Access Compliance Report

Public Rights-of-Way

Intersection ID: N/A	Main Street: PERTH_MOOR_RD	Cross Street: HAMILTON_BRIDGE_RD	Location: SE
ADA ID: C12211ACF4DB	Ramp Type: BlendTrans2	Initial Pass/Fail: Fail	Overall Compliance: No
		Severity Score: 8.75

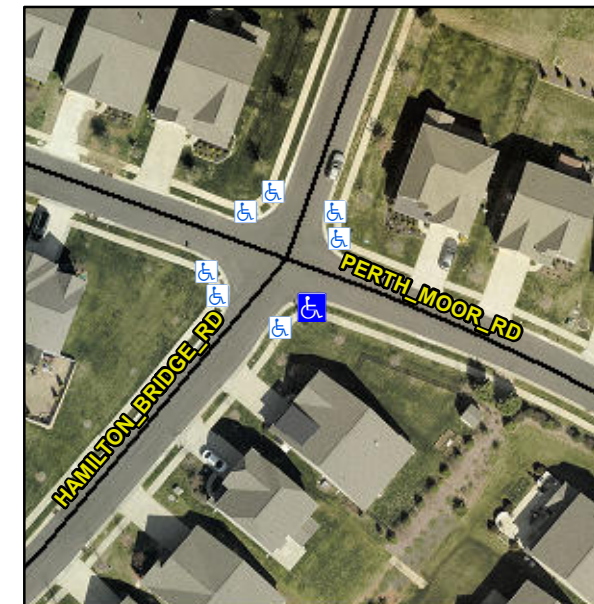
R304.5.1

Remove & Replace Curb Ramp With Two New Directional Ramps or Equivalent.
